Vernon-Sicilian House & 21 Southampton Row

Conservation Officer Comments - HBA Response
December 2022

This document has been prepared in order to address some of the comments received by the London Borough of Camden's Conservation and Heritage team on 9 November, 2022, regarding the proposed refurbishment works to Vernon and Sicilian House and 21 Southampton Row, which constitute Project 1 of the Holborn Links Estate.

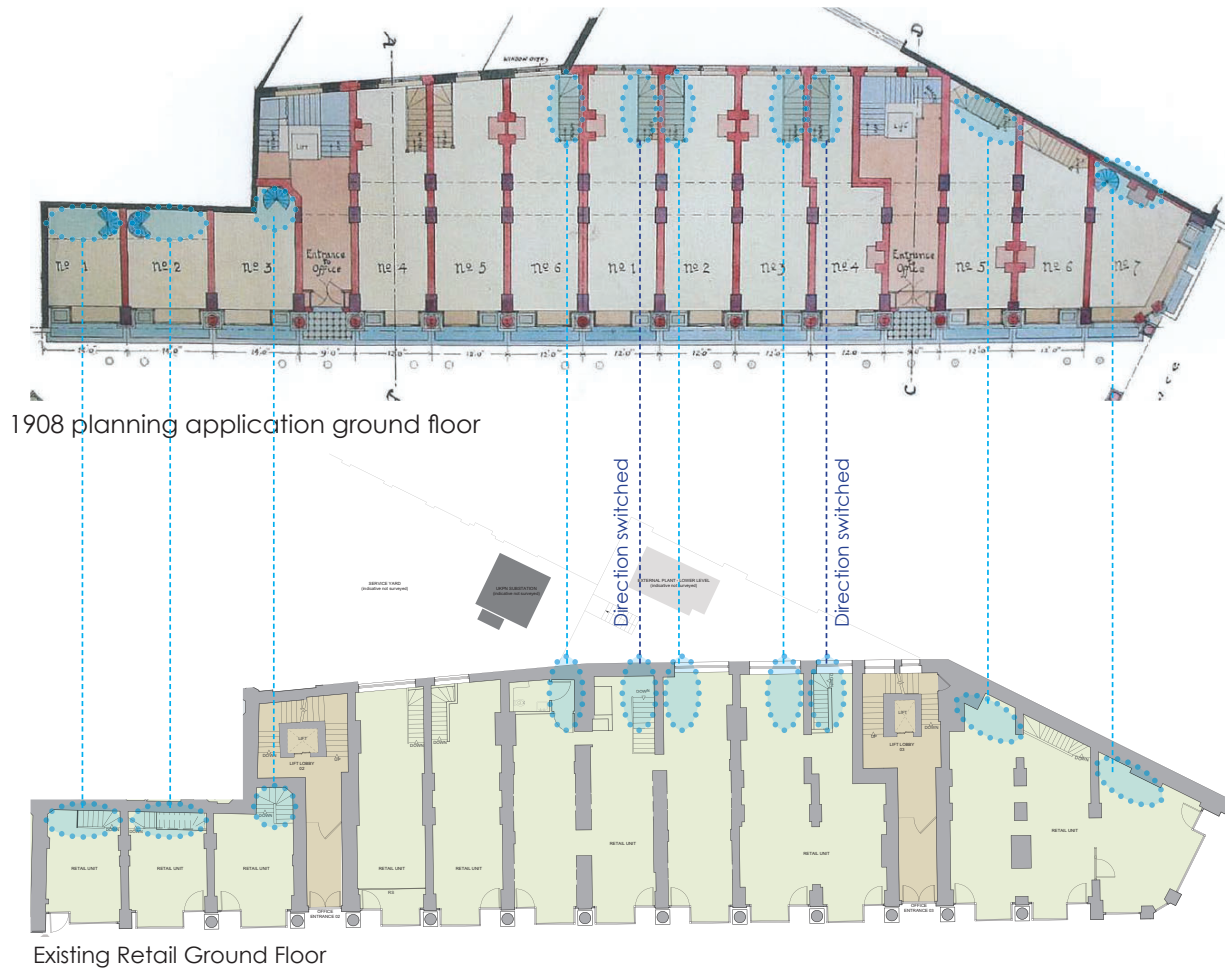
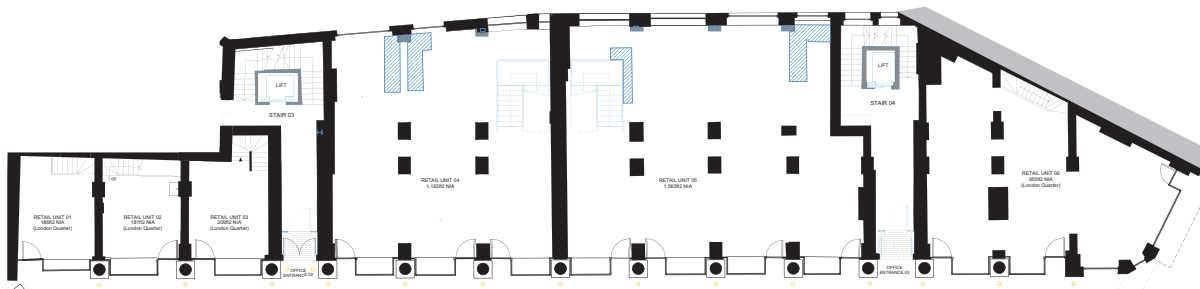
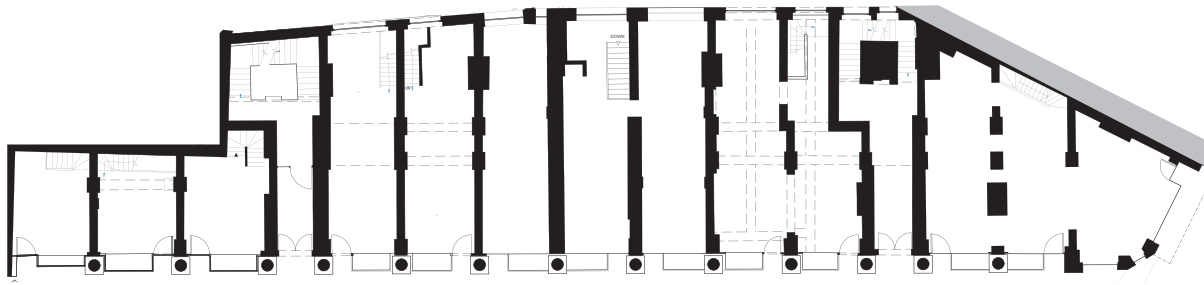
**'Along the Sicilian Avenue retail parade, all historic staircases
should be retained.'**

- The proposed retail amalgamation works are limited to the units between the cores of Vernon and Sicilian Houses
- Within these units it is proposed to remove the remaining separating masonry walls but retain the high strength brick piers, to create 2no. larger more open plan units

- This arrangement is driven by the market requirement to create two larger flexible units with basement fully accessible to the public
- While this arrangement would remove 2 staircases understood to be original, retaining these staircase for general public access and use is not possible due to their restricted widths.

- As the retail units are being enlarged, access to the basement will need to comply with the requirements of Approved document K of the Building Regulations, which states that for buildings other than dwellings, stairs should have a width of 1200mm. All of the existing staircases in the retail units have widths less than 1200mm.

Proposed Retail Ground Floor - showing revised structural proposals

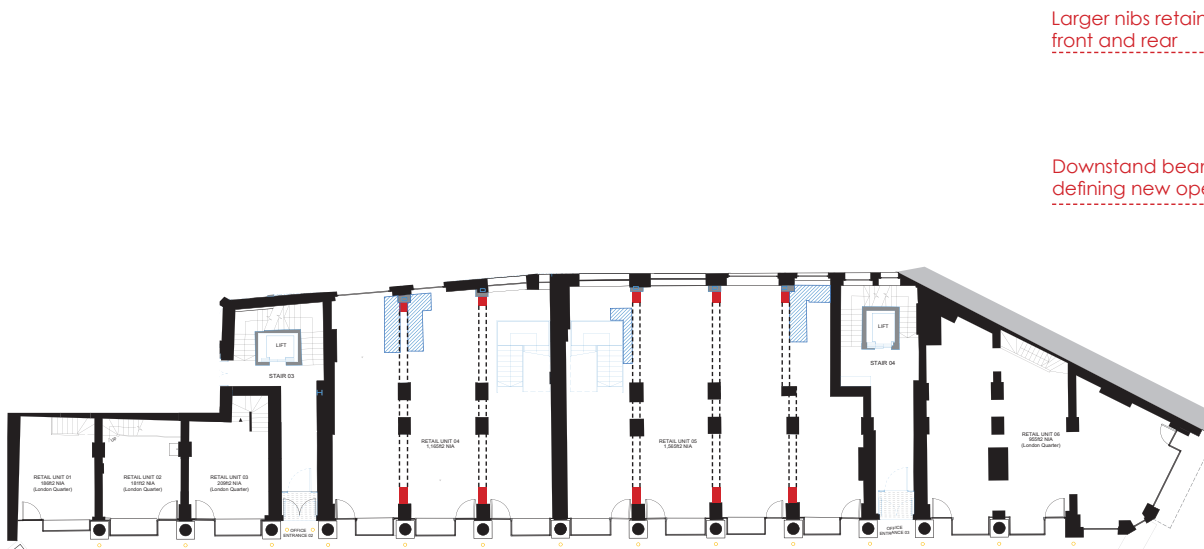
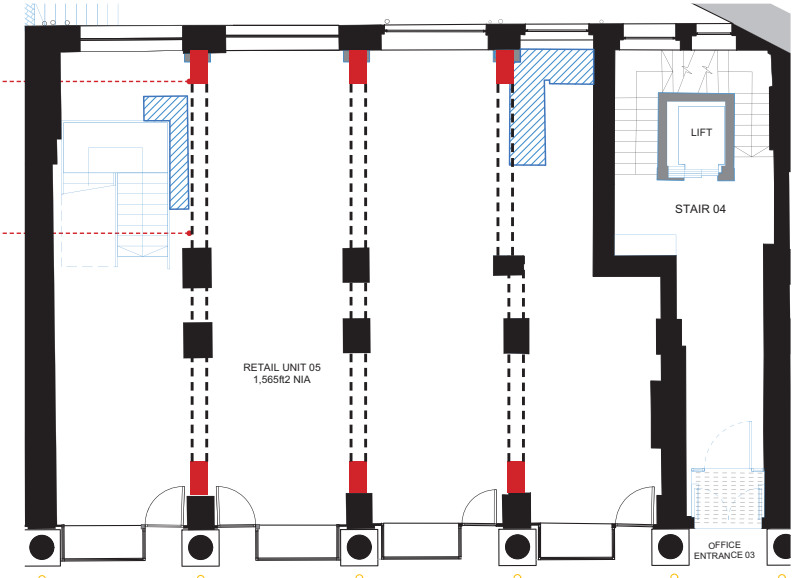
'Along the Sicilian Avenue retail parade, the openings created between each unit at ground floor should be reduced – i.e., more wall should be retained to ensure the small-scale plan form is legible.'

- In order to ensure the small-scale plan form is more legible within the amalgamated units the revised proposals would look to retain larger nibs at the front and rear of the units where separation walls are proposed to be removed
- The walls locations would be further defined within the space via deeper downstand beams
- When viewed from both externally and internally the rhythm of the original unit bays would be clearly legible

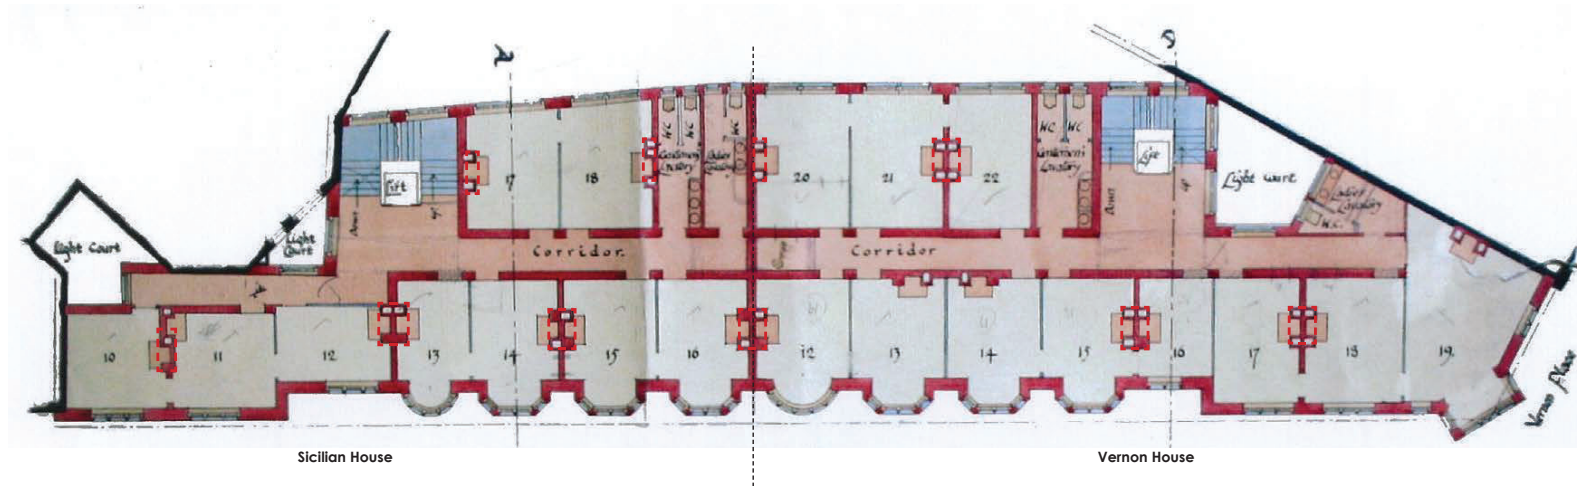
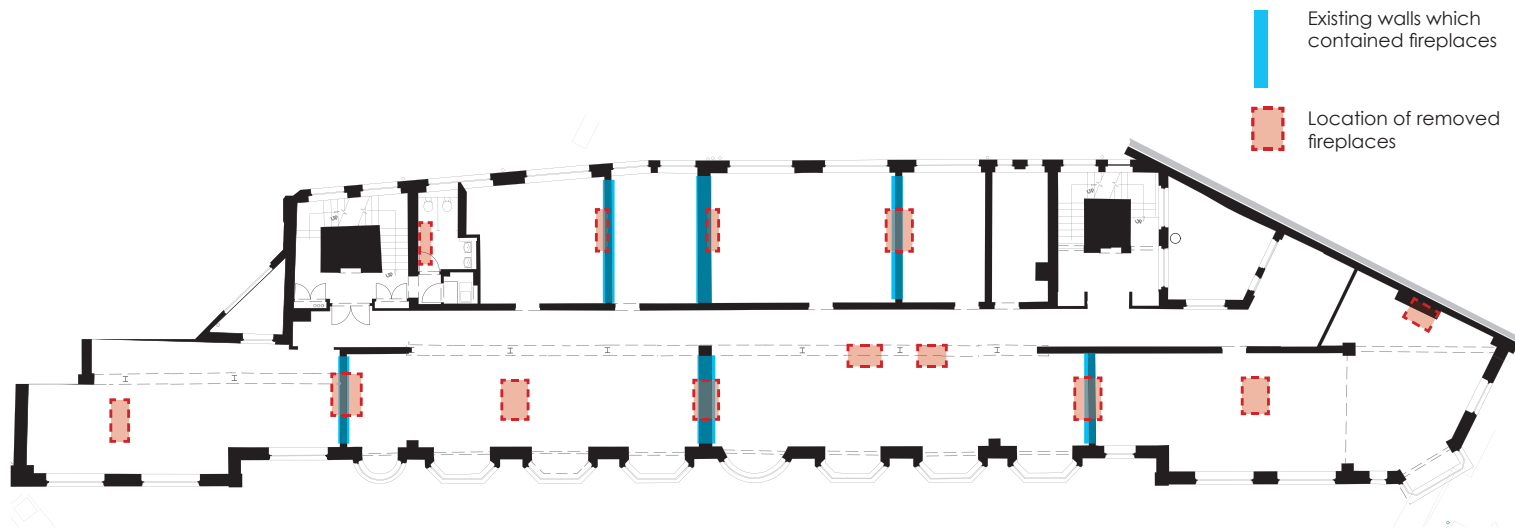
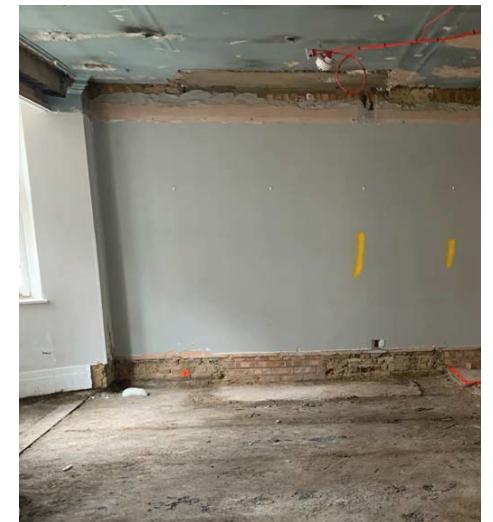
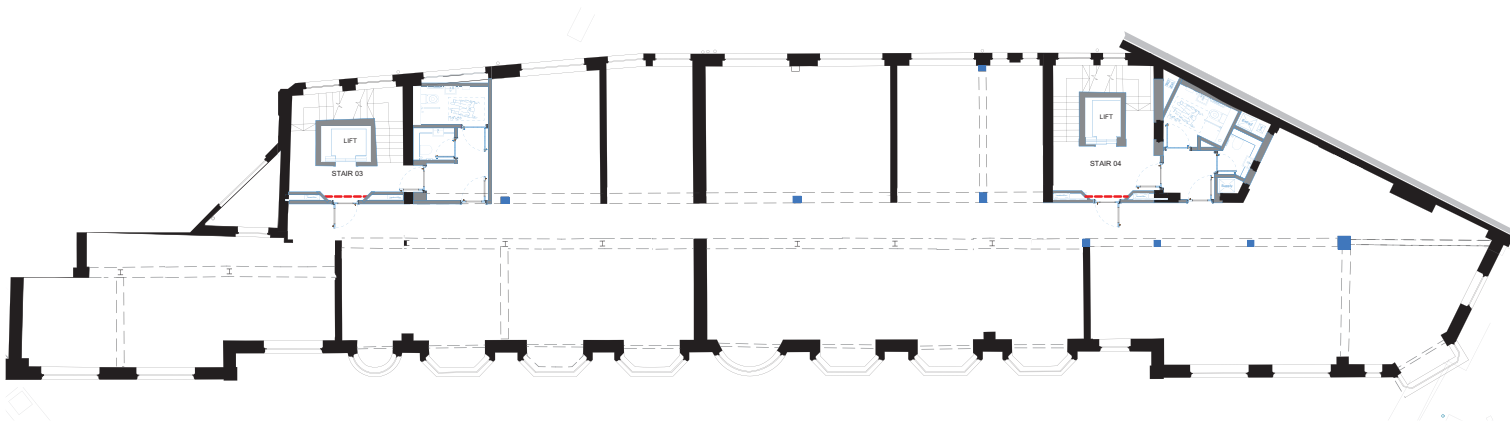
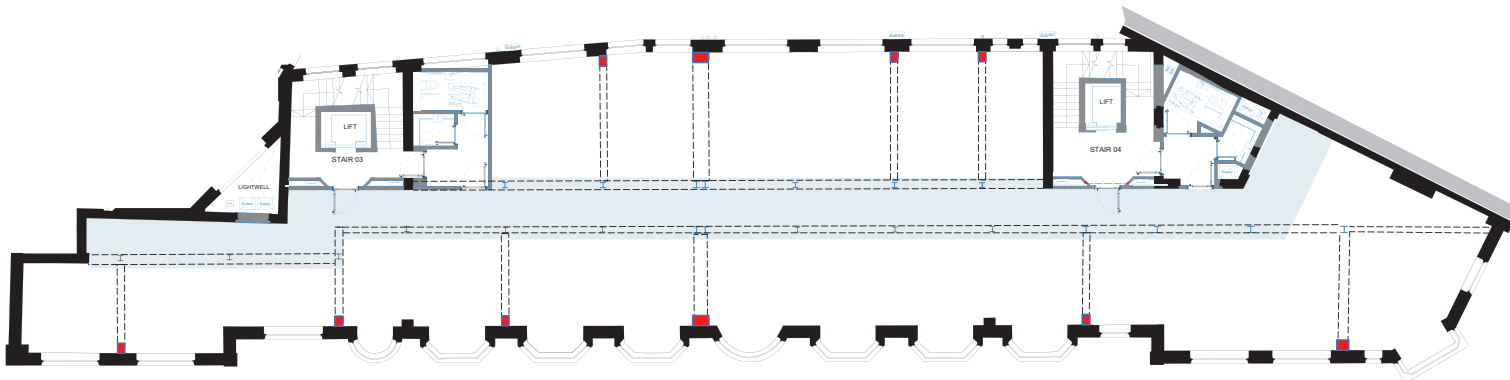
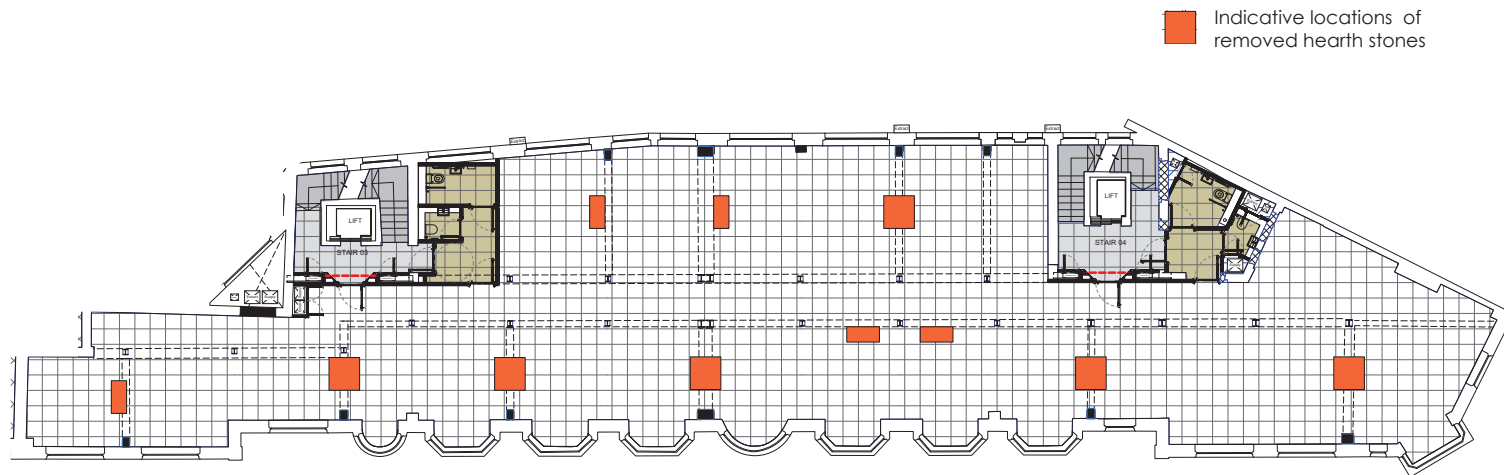
'On the upper office floors of Sicilian and Vernon House, the vertical walls that contained fireplaces should be retained.'

- Subsequent to the approved strip out works, the extent of alterations undertaken to the office walls in the 1970's is clearly evident
- While some walls remain where chimneys had been positioned, the chimney breasts and hearth stones have been removed and chimney flues have been filled with modern bricks

- If only the existing walls that previously had chimneys were retained, not enough of the original fabric would be legible for the historic layout to be understood

- Therefore the remaining walls could appear incongruous within the floor plate
- Additionally market feedback has stated that the restriction caused by the retained walls would remove tenant flexibility for the layouts of the floors

- As a consequence the ongoing use and occupation of the building would therefore be at risk
- An alternative proposal that would provide a consistent language across the floors would be to define the original walls through extended nibs at the perimeter walls

- The nibs would then support downstand beams which would run to central columns, either side of the original circulation corridor
- This historic circulation corridor would then be further reinforced by the presence of the service raft

- With this proposal the historical layout would be clearly recognisable, within a bright and flexible floor plate

Proposed second floor plan indicating position of original chimneys and hearth stones

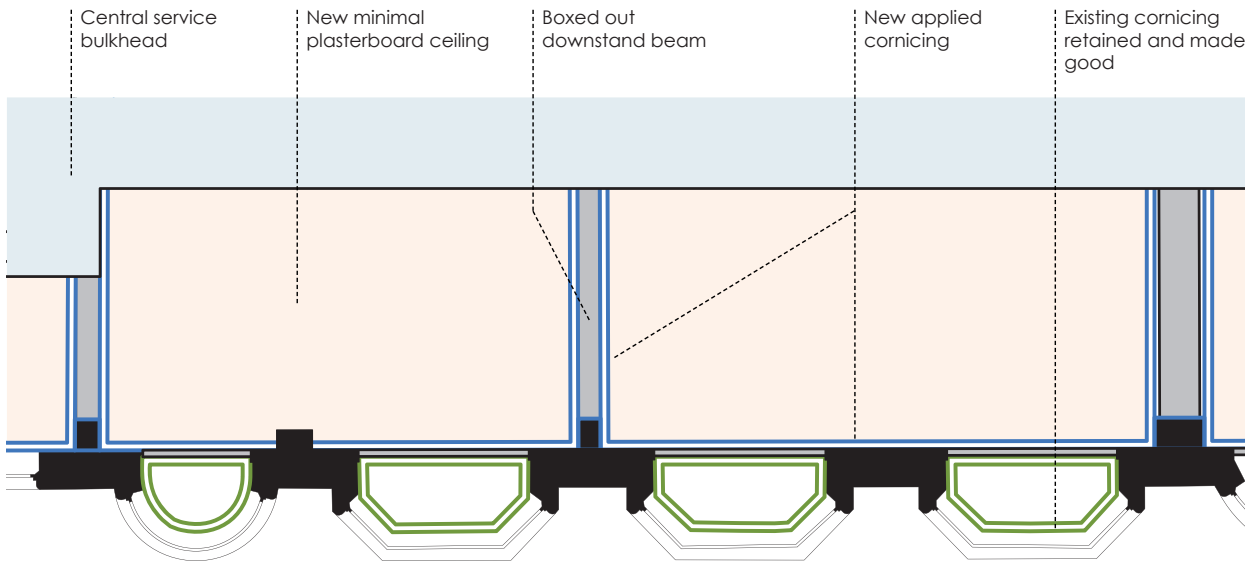
'On the upper office floors of Sicilian and Vernon House, efforts should be made to reinstate historic features – e.g., parquet flooring, cornices, and hearth stones of fireplaces.'

- The refurbishment works look to deliver flexible Cat A office spaces where incoming tenants can arrange and fit out the floors as per their individual requirements

- Offering this flexibility is paramount to attracting the widest range of potential tenants, to ensure the longevity of the building's use
- In line with market expectation for a flexible Cat A office space the intention is to install raised access floors within the offices

- The installation of new hearth stones in the historic positions across the floor plates would remove the option of installing floor boxes in these locations and therefore adversely effect the floors lettable

- While the installation of parquet flooring would undoubtedly enhance the look of the office spaces, as the tenants and requirements are not known, this floor finish would need to be removed to allow tenants to install underfloor cabling

- As reinstating and fitting the flooring would be very costly it cannot be guaranteed the incoming tenants would undertake this
- Therefore from a sustainability perspective this type of flooring or any additional floor covering on top of the raised access floor would not be preferable

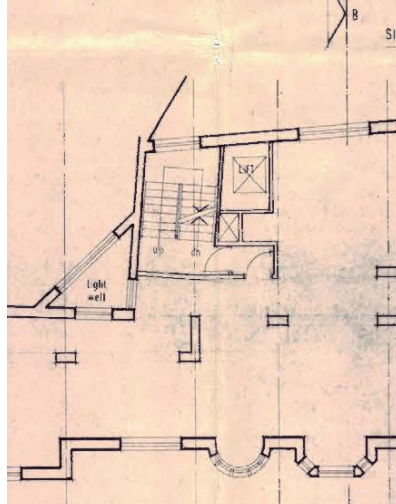
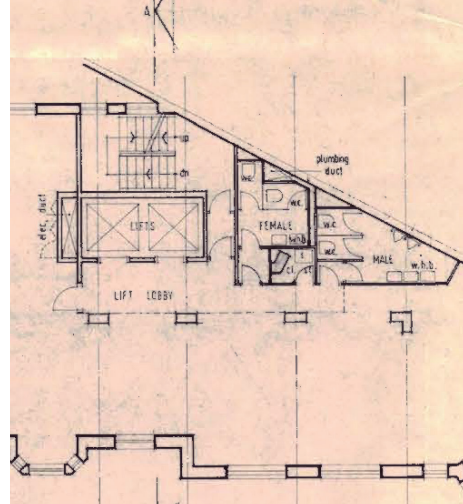
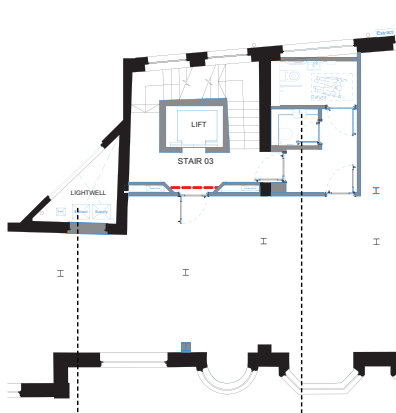
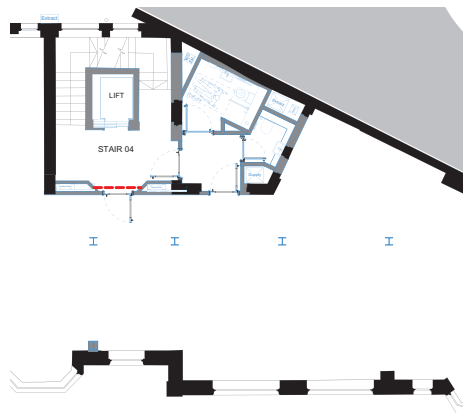
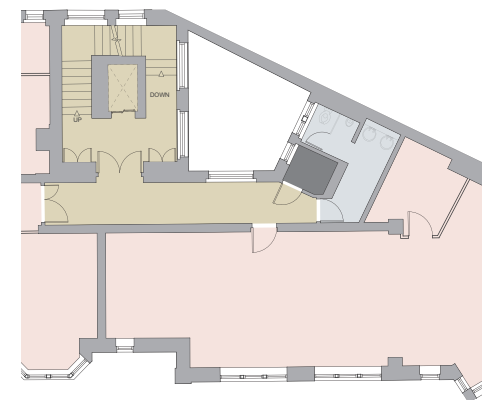
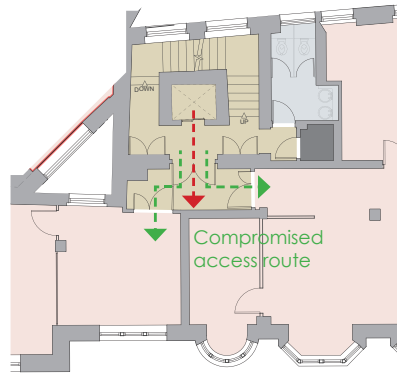
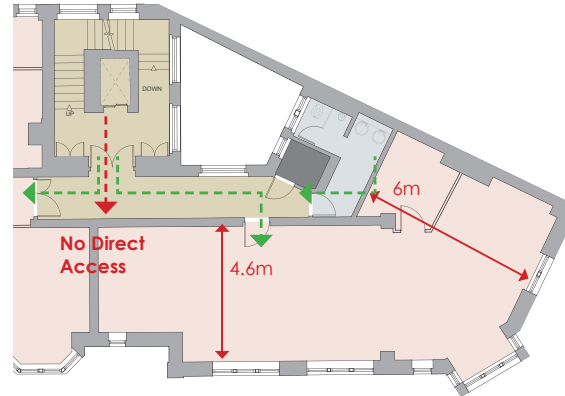
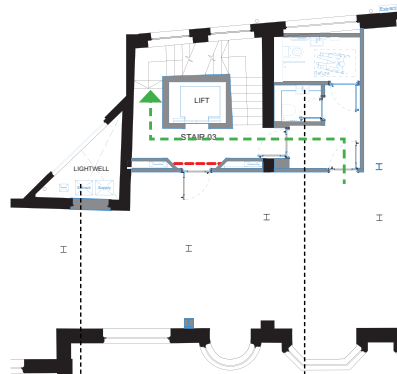
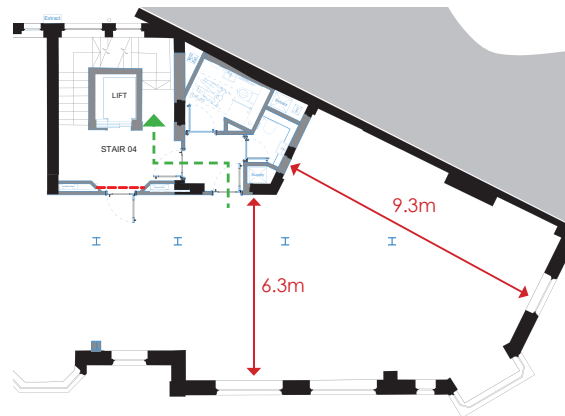
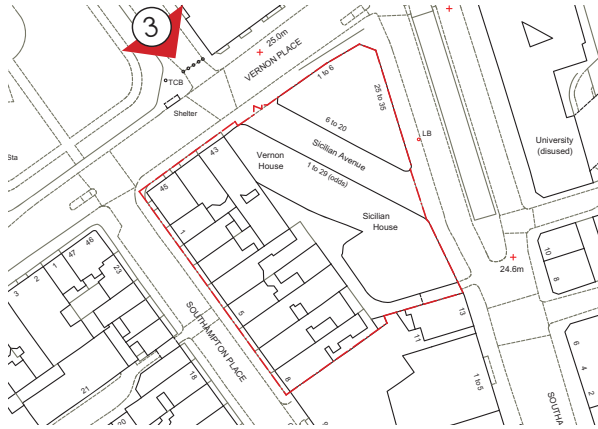
'On the upper office floors of Sicilian and Vernon House, the lightwells should remain as existing, with WCs moved internally.'

- Under the approved 1970's planning application both Sicilian and Vernon Houses cores were proposed to be completely reconfigured with new stairs and lifts
- Within Vernon House the lightwell was completely infilled to create male and female WC's
- While the lightwell within Sicilian House was retained the benefits it creates to the office environment is extremely limited due to the proximity of 21 Southampton Row
- While Vernon House's lightwell is larger in its pre-strip out configuration the office space did not benefit from its natural light
- Small WCs alternating male and female on different floors and access routes surround the lightwell
- The existing separation wall also prevented daylight penetration into the offices

- As the building does not have a ducted fresh air supply to the floors, as part of the overall improvements to the building a new mechanical fresh air system is proposed

- The system relies on an air handling unit being installed on the roof with supply and extract ducts running down to the floors below
- Due to the size of the ducts large sections of the floor plates would need to be removed to create the vertical risers

- Therefore running the ductwork down the lightwells would overcome this while also retaining valuable lettable office space
- Locating the WC's within the remaining area of Vernon House's lightwell would dramatically improve the usability of the floor plates and provide maximum outlook onto Sicilian Avenue and Bloomsbury Way

- The location and configuration of the new WC blocks also enables them to form the lobbied escape routes from the offices
- The revised layout enables the arrival in the lift lobbies to provide a good first impression with direct access and uninterrupted views of Sicilian Avenue, through the new glazed doors with secondary protective fire curtains
